HISTORIC PRESERVATION REVIEW BOARD STAFF REPORT AND RECOMMENDATION

Address: 1326 Valley Place SE

Meeting Date: October 23, 2014 (x) Addition
Case Number: 14-717 (x) Alterations

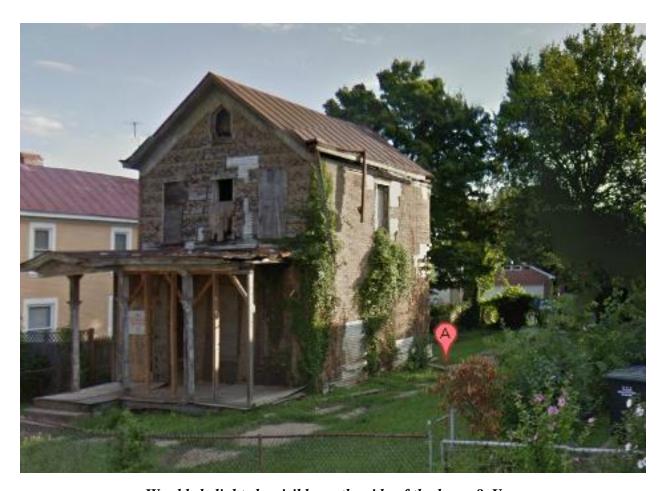
Would skylights be visible on the side of the house? Yes.

- the main block be constructed to its original depth, be sided with wood siding to match the original profile and exposure, and have fenestration generally consistent in size and proportions; and
- there be no skylights installed on the principal roof.
